Subject: **CORRECTING NOISE AND PICTURE LOSS**

Model: **BKM-21D**

Serial No: **2,002,450–2,004,629**

Figure 1

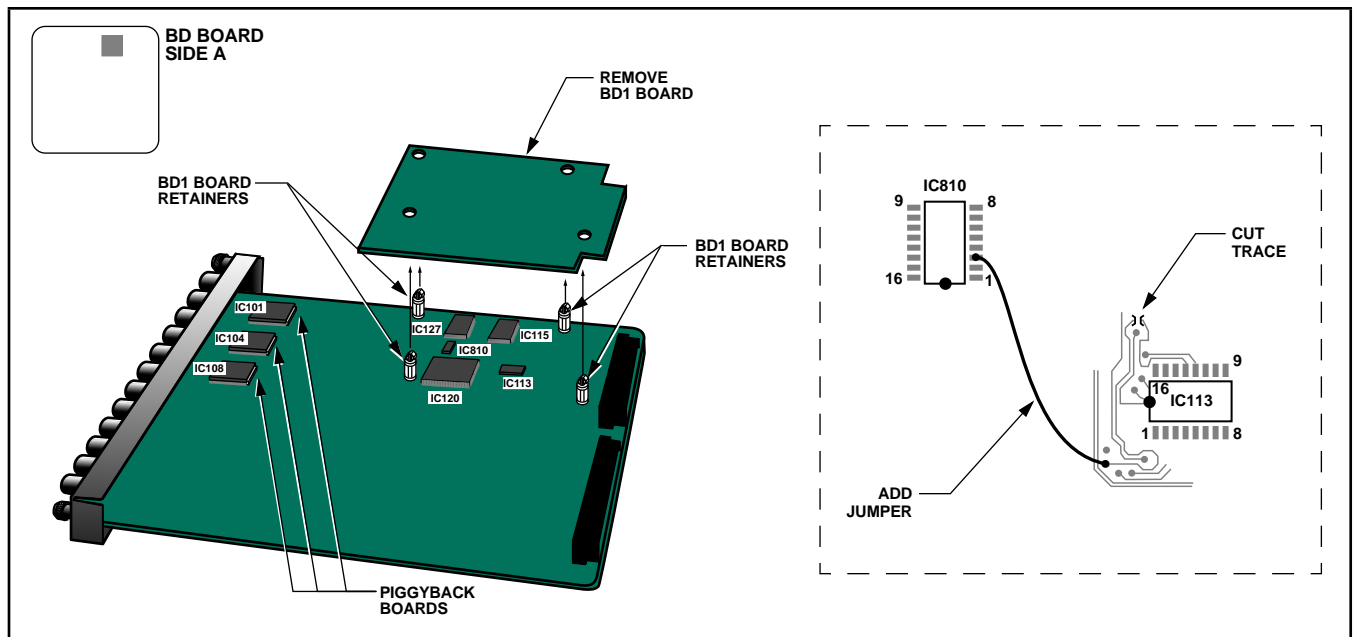
When the unit is installed in a BVM Evergreen Series video monitor and a D2 NTSC signal is received, white horizontal stripe noise may occur or the picture may disappear at startup or in a low temperature environment. In such cases, the piggyback boards beneath IC101, IC104, and IC106 may malfunction.

To correct this condition, use the DPR terminal (pin 31) of IC127 (side A, A-12) for detection of SDI signal input, instead of the DPR OUT terminals (pin 23) of IC101, IC104, and IC106, by performing the following modification procedure.

1. Ensure that piggyback boards are mounted beneath IC101, IC104, and IC106 on the BD board (zones A-6, B-6, and C-6, respectively).

2. Using tweezers or pliers, remove the piggyback BD1 board mounted on the BD board.
3. Cut a trace leading from pin 13 of IC113 (zone B-13) as shown in Figure 1, inset.
4. Solder a jumper between pin 3 of IC810 (zone B-12) and the land near IC113 as shown in Figure 1, inset.
5. Reinstall the BD1 board.
